RE: Material License #24-04206-12MD (Kansas City)

Please amend the above referenced material license to reflect the following modification:

ATTACHMENT I VENTILATION SYSTEM DIAGRAM

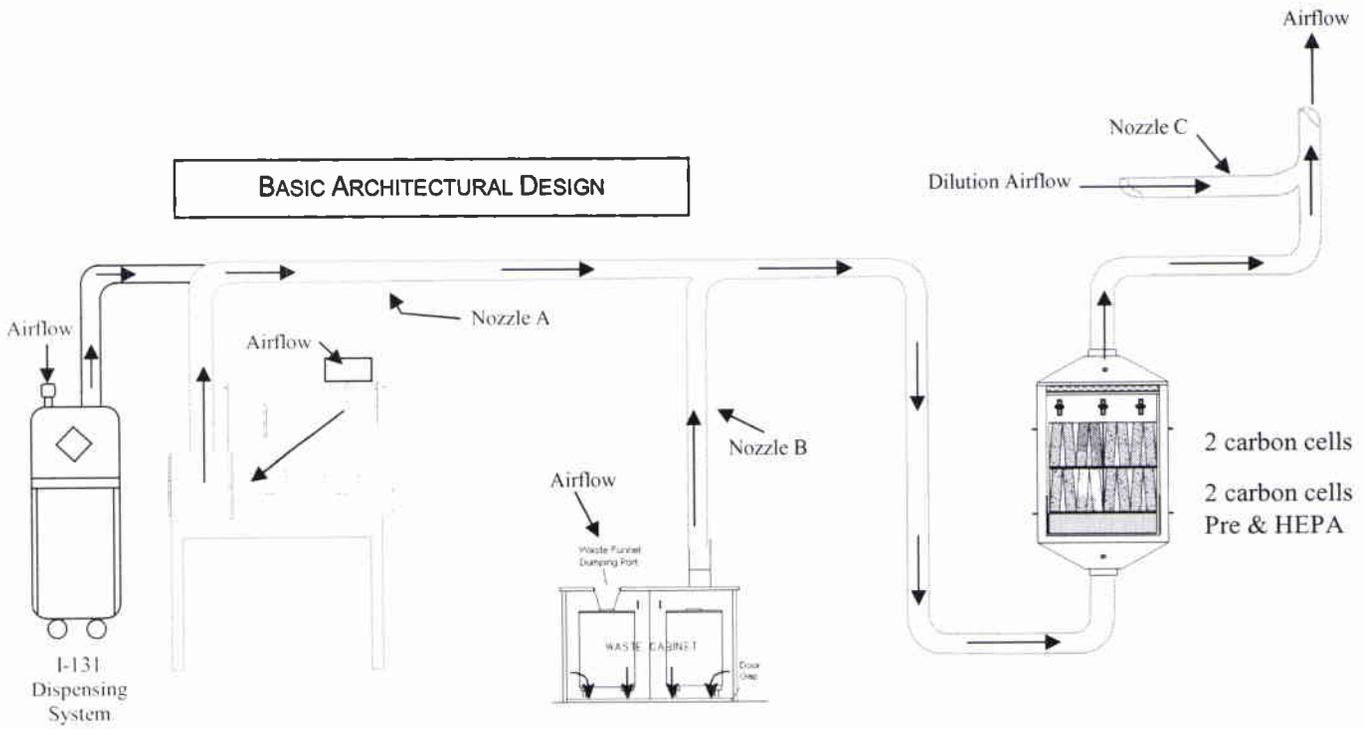
1. Add an Iodine-131 automated dispensing system to the list of equipment in Item 9, "Facilities and Equipment" of the current license application. This dispensing system will be used to make Iodine-131 therapy products. The exhaust will be tied into the existing glove box exhaust line. Ventilation system parameters will be unchanged. A revised diagram, depicting the dispensing system addition, is provided in Attachment I and will replace Appendix E. The revised facility diagram depicting the location of the dispensing system within the restricted area is provided as Attachment II and will replace the facility diagram in Appendix D of the current license application.

After receipt of the unit, a 2" PVC duct leading from the dispensing unit will be mechanically connected to the existing 6" ductwork and mechanically sealed. The 6" ductwork is part of the independent ventilation system which provides negative pressure to the current glove box and waste cabinet.

To ensure no leakage, the connection to the ventilation system will be mechanically sealed and silicone caulk applied to all sealing surfaces. The existing manometer will continue to monitor air flow at all times to ensure the system is at negative pressure to the environment. Breathing zone air samples will be collected and analyzed weekly at the dispensing unit, glove box, filter unit and waste cabinet and analyzed for I-131 airborne radioactivity

ATTACHMENT III
DRAxIMAGE SMART-FILL™ DISPENSING UNIT PHOTOGRAPH

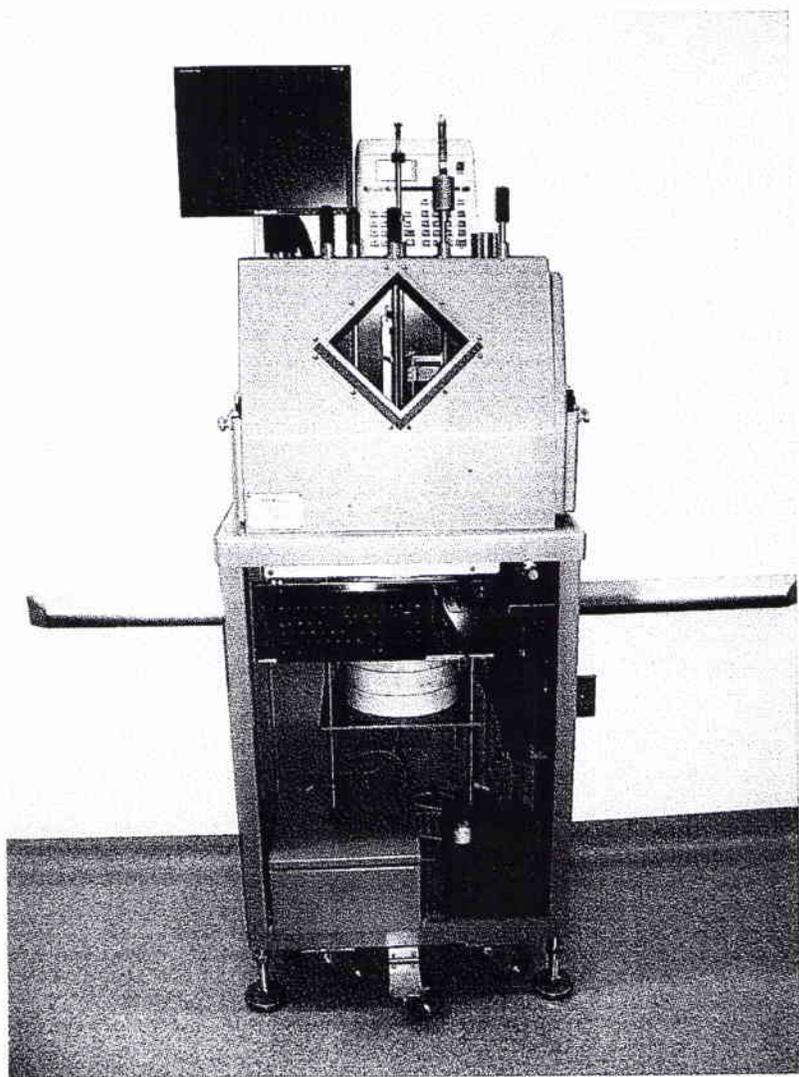
The DRAXIMAGE Smart-Fill™ (patent pending) capsule-filling machine (photograph provided in Attachment III) is a computer-controlled dispensing unit which consists of: a shielded enclosure, manipulator and transfer arms, integrated dose calibrator, and a multi-well carousel for the preparation of custom I-131 capsules. The unit is shielded with an inch of lead on the front and sides and a half inch of lead on the back. The system allows for improved radiation protection and precise and reproducible dispensing. The computer interface allows personnel to generate a detailed report containing order information such as activity ordered, calibration date, volume dispensed, production date and operator name.

The dispensing unit has been modified in two areas. One modification is to adjust an internal capping unit to meet the specifications of the vendor-supplied vial. The second modification is to adjust the vial shield holder to meet the specification of Covidien's custom made vial shield. These modifications will not affect the integrity of the lead shielding or air seals within the dispensing unit.
